Technical Service Bulletin

TSB0906: King Fork Cartridge Tube

January 27, 2006

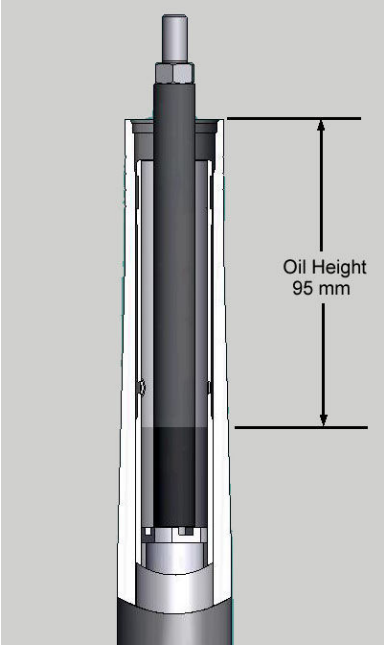
On all 2006 Cobra King models, Cobra Motorcycle Manufacturing is changing the fork cartridge tube from an aluminum tube to a more rigid '5-star' steel tube. This component will be available to the customer at no cost.

Forks with the '5 star' cartridge should be filled with 107cc of quality 7wt fork oil.

NOTE:
For best performance do not use less than 105 cc or more than 110 cc of oil. This equates approximately to a minimum oil height of 90mm and a maximum of 100mm measured as shown below (spring out, rod & tubes collapsed).
